File Number: 8-B-26-IH

Meeting: 8/19/2026
Applicant: R. Eberto Arellano ROE Construction, LLC
Owner: Jorge Mercado
District: Lonsdale Infill Housing Overlay District

Location: 3359 Midway St. **Parcel ID:** 81 H C 017
Zoning: RN-2 (Single-Family Residential Neighborhood), HP (Hillside Protection Overlay)
Description: New primary structure

8-B-26-IH
APPLICATION FOR CERTIFICATE OF APPROPRIATENESS

EXTERIOR ELEVATIONS

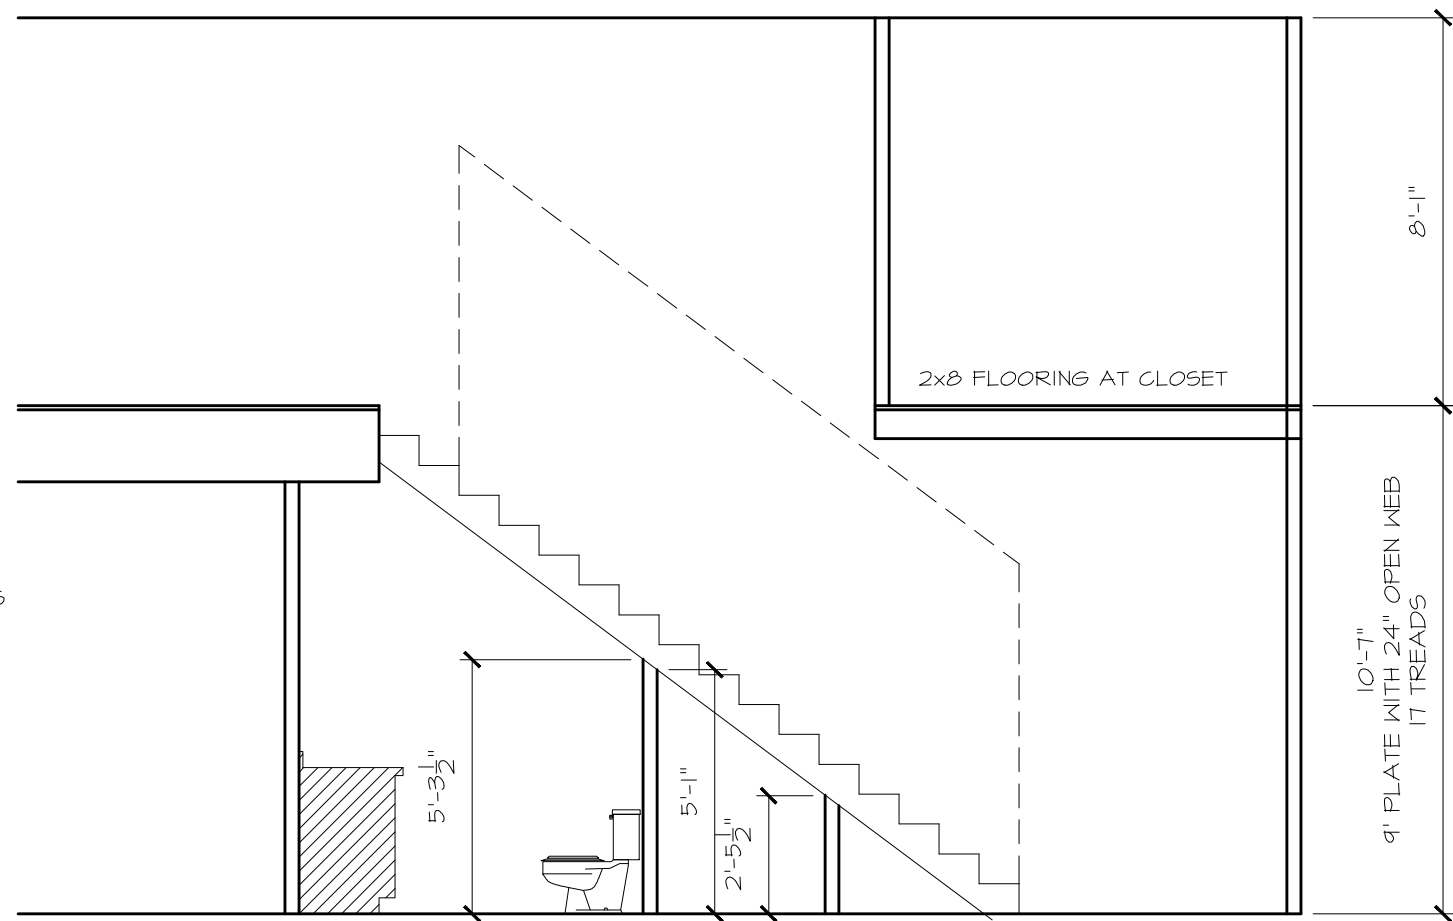
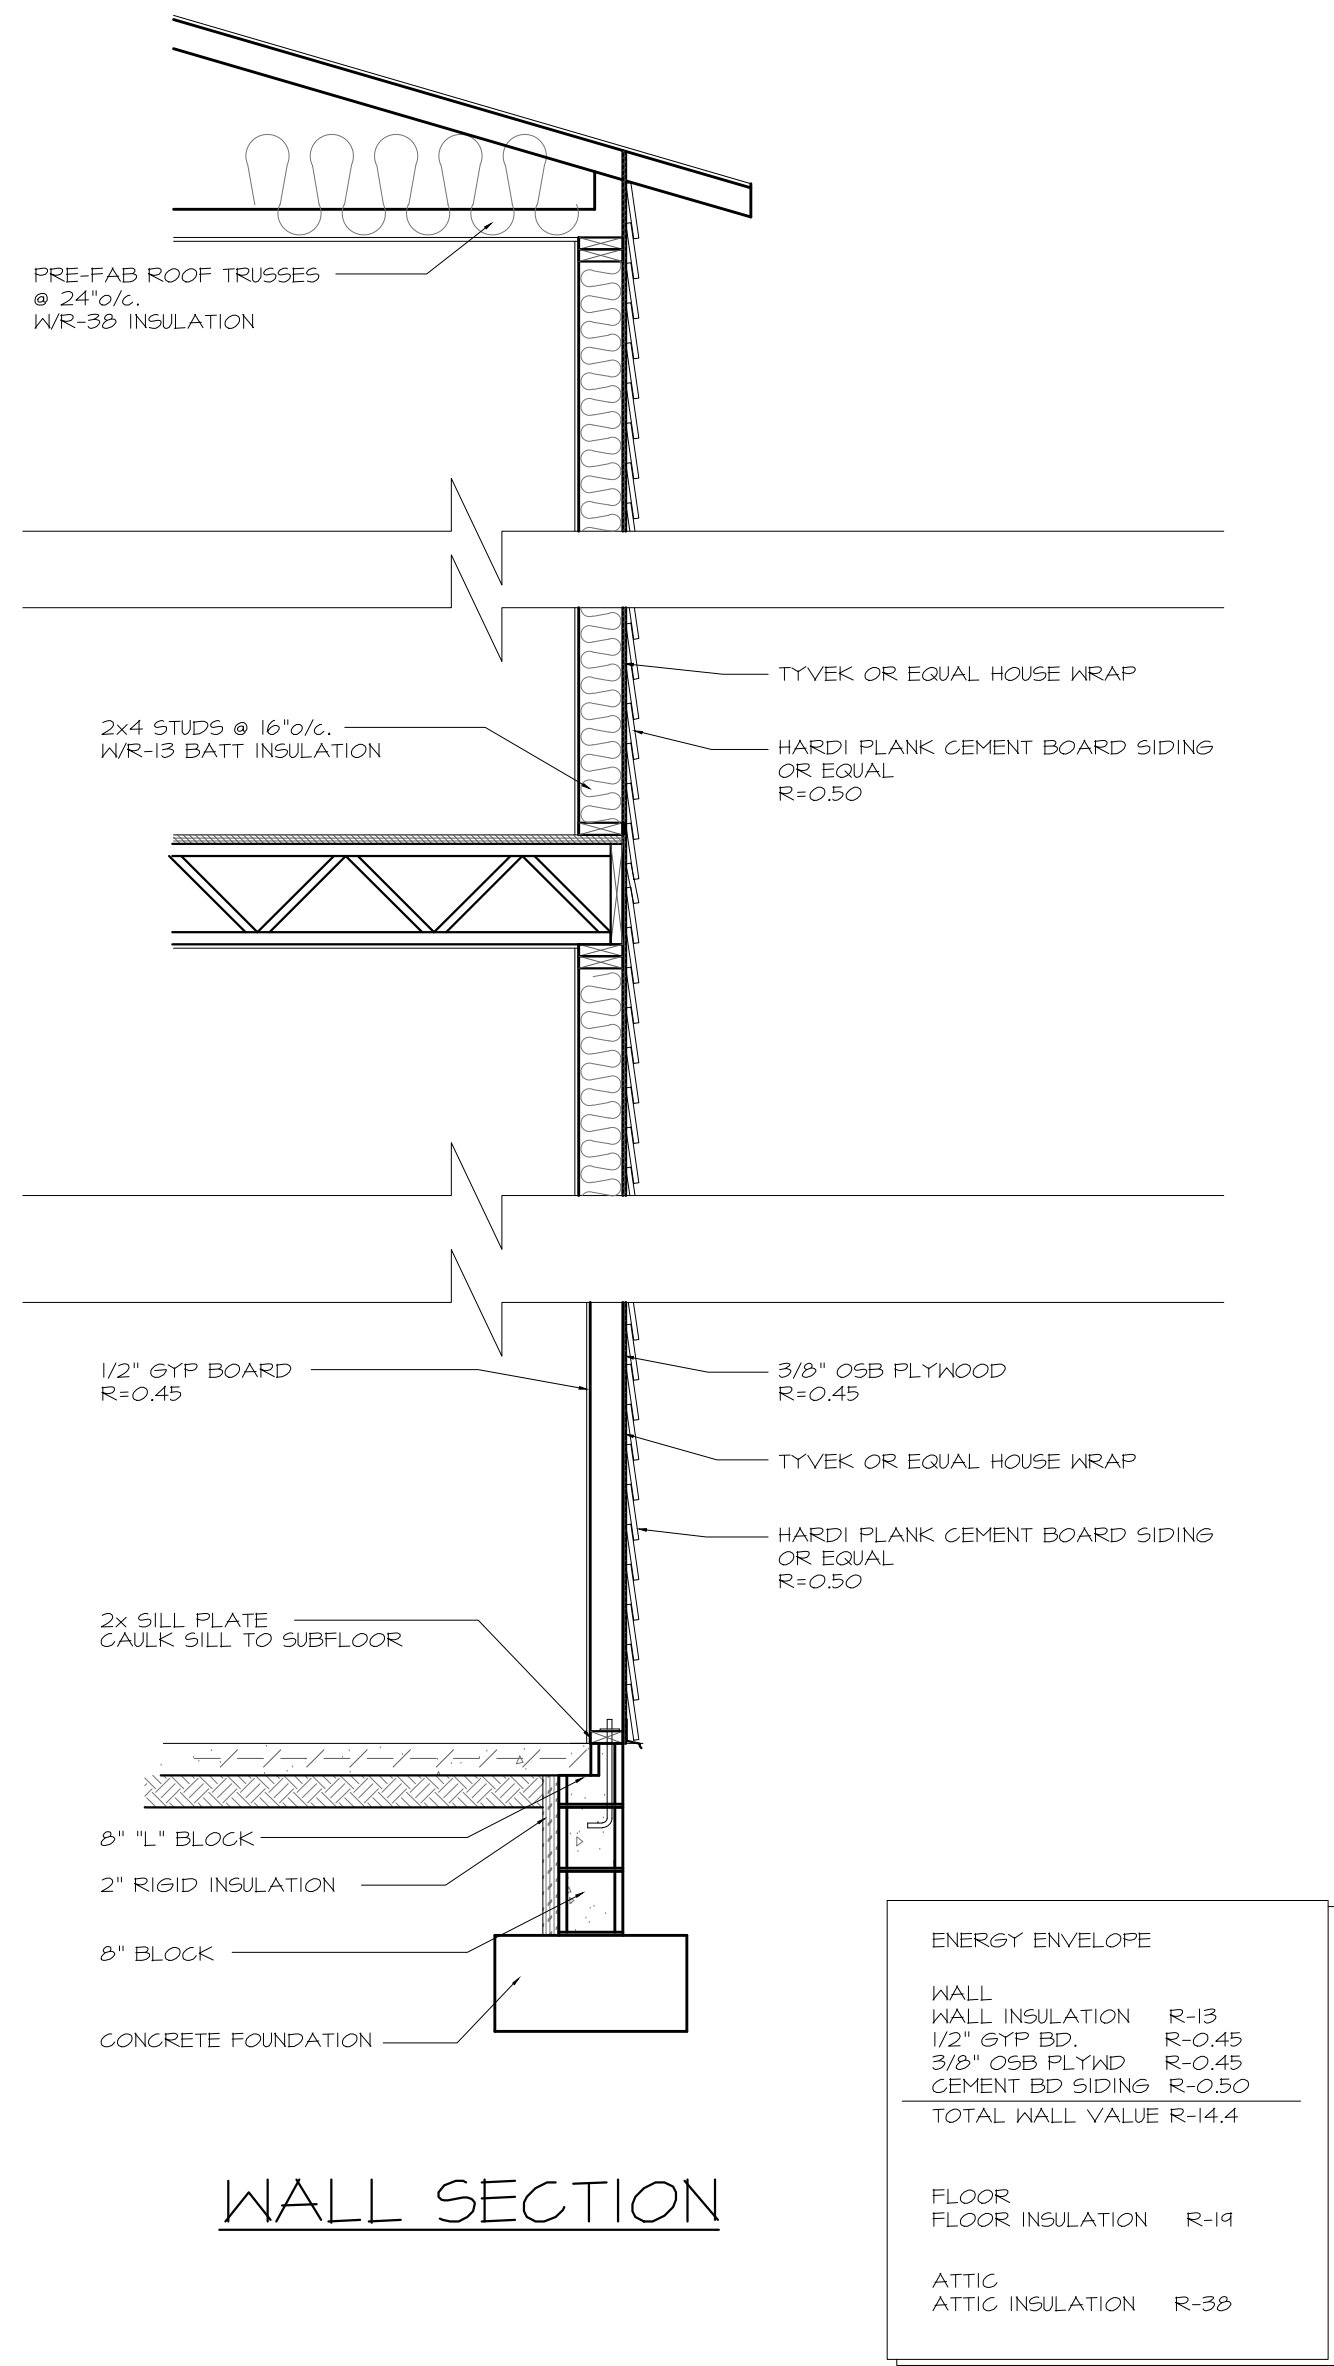
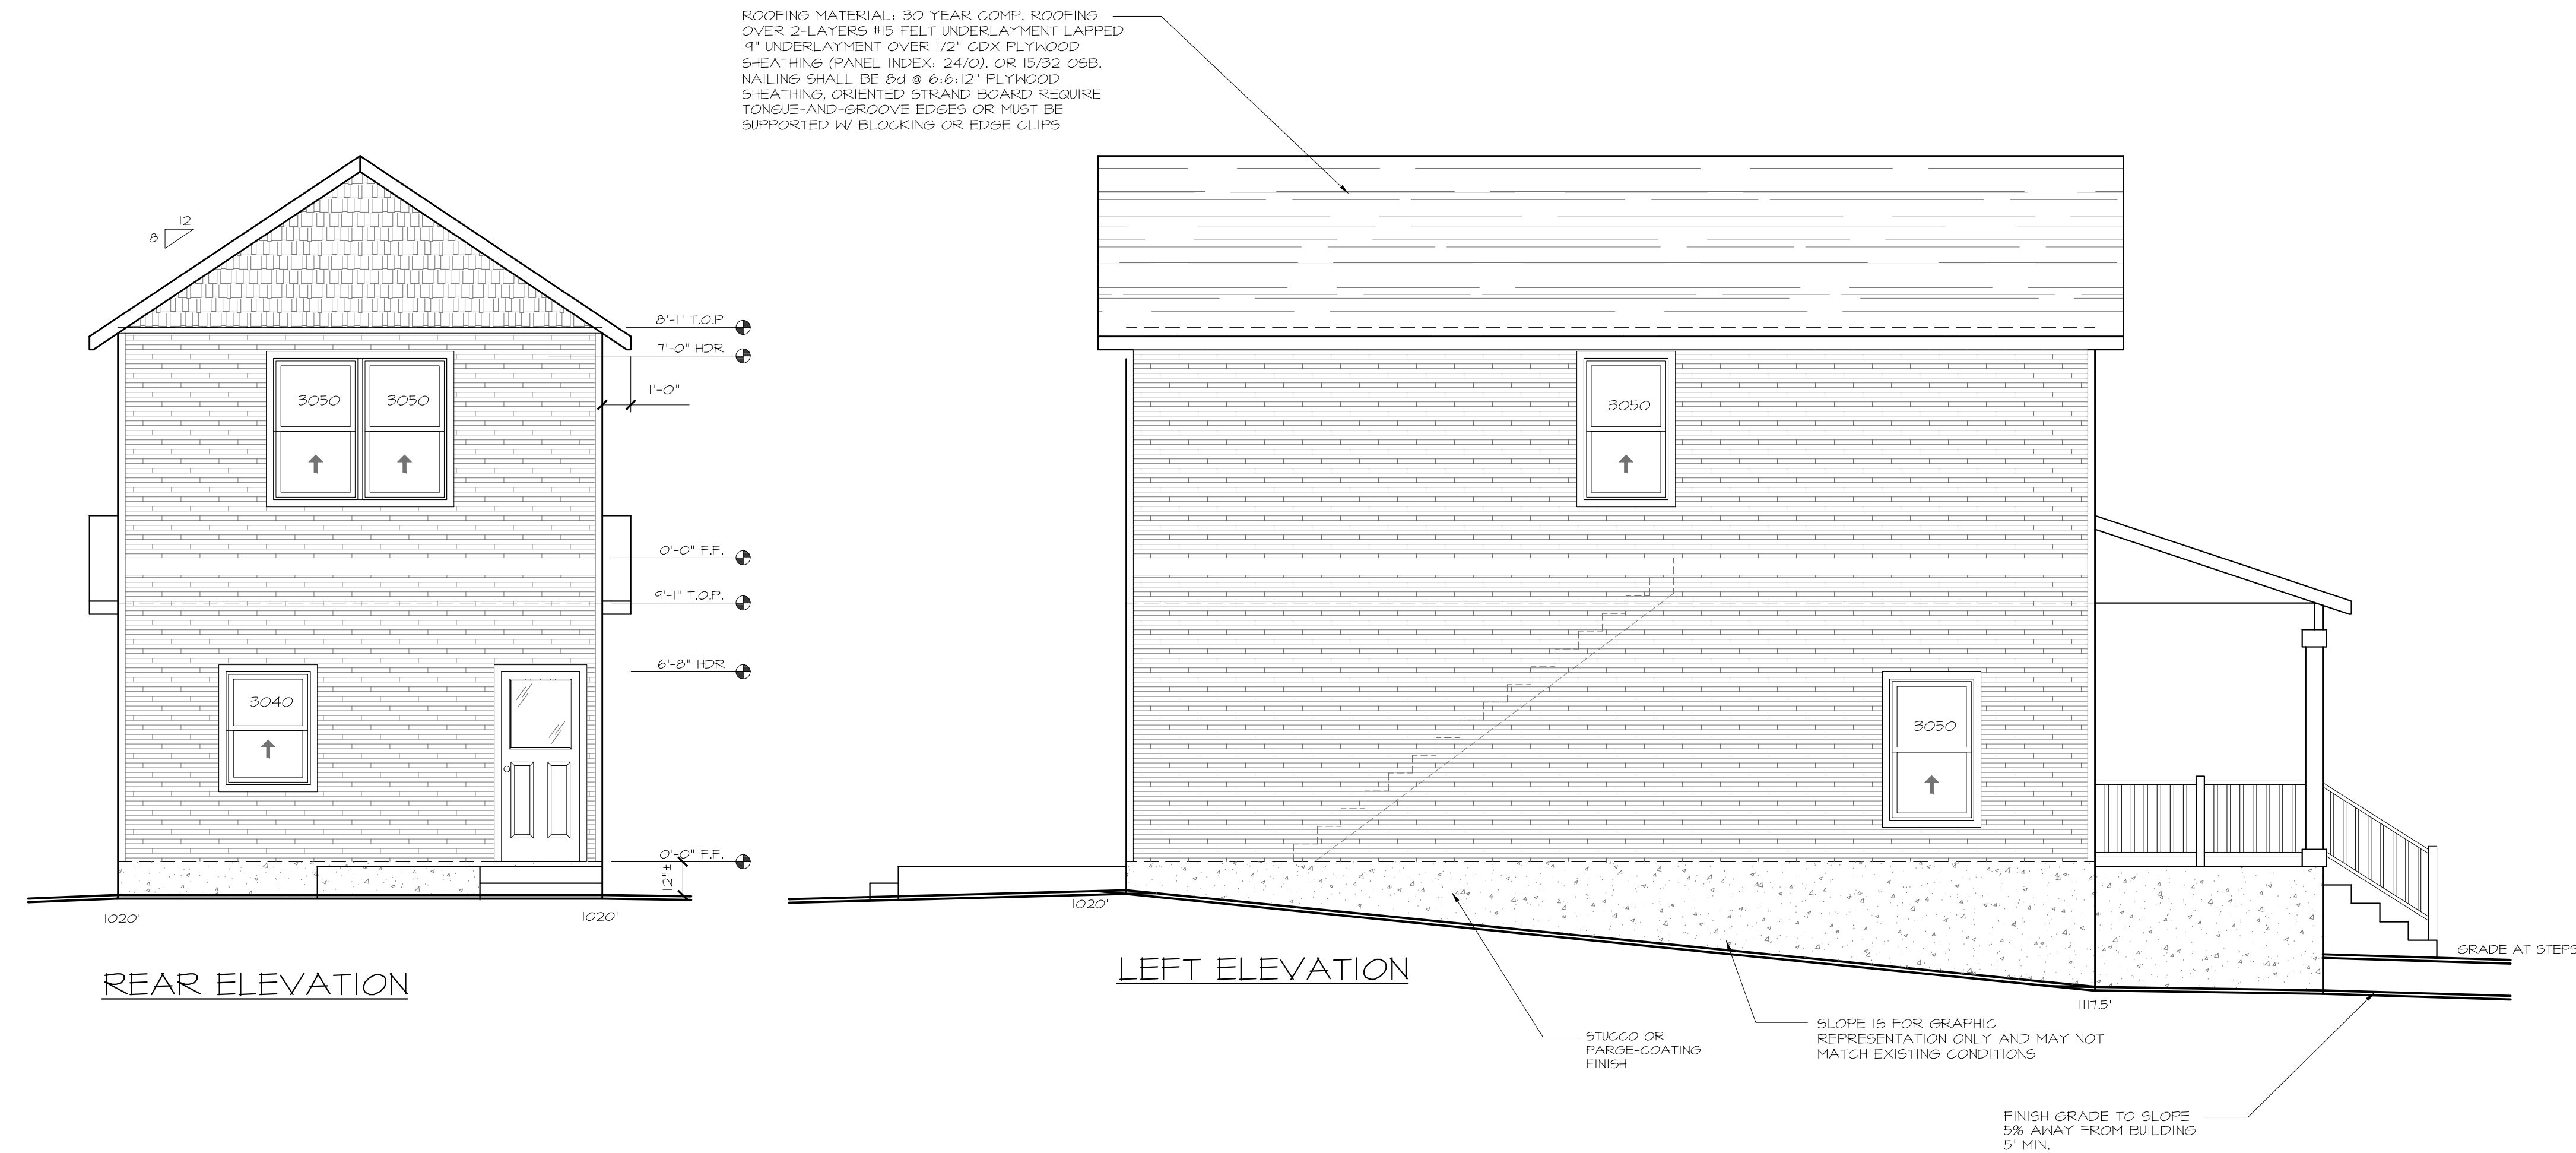
The two-story building features an exterior of lap siding with shakes in the gable fields and trim dividing the stories, an 8/12 pitch front-gable roof with overhanging eaves, and a block foundation that will be clad in stucco or parge-coated and measures 3'-6" tall at the façade and 1' tall at the rear elevation. The façade (east) features a full-length, 8' deep front porch with a shed roof that is supported by three 8" square posts, paired windows and a half-lite paneled door on the first story, and paired windows on the second story. The right elevation features paired windows on the first story and one window on the second story, and the left elevation features one window on each story. The rear elevation features paired windows on the second story and one window and a secondary entrance with a landing on the first story.

Scale, Mass, and Foundation Height: The block primarily features Minimal Traditionals and Craftsman bungalows that are all one-story or one-story with a basement level, and two-story infill construction was approved and constructed this year. The visual scale of the two-story house is mitigated by the trim dividing the stories and the deeper front setback to the main massing relative to the adjacent houses. The lot is also narrower than most houses on the block, but the width is appropriate given the topography and irregular shape of the lot.

- 1) the final site plan to meet City Engineering standards, with minor revisions to be approved by staff;
 - 2) major changes to the foundation height to return to the Board for review;
 - 3) allowing for an 11' combined side setback because it is compatible with site constraints and surrounding development.
-
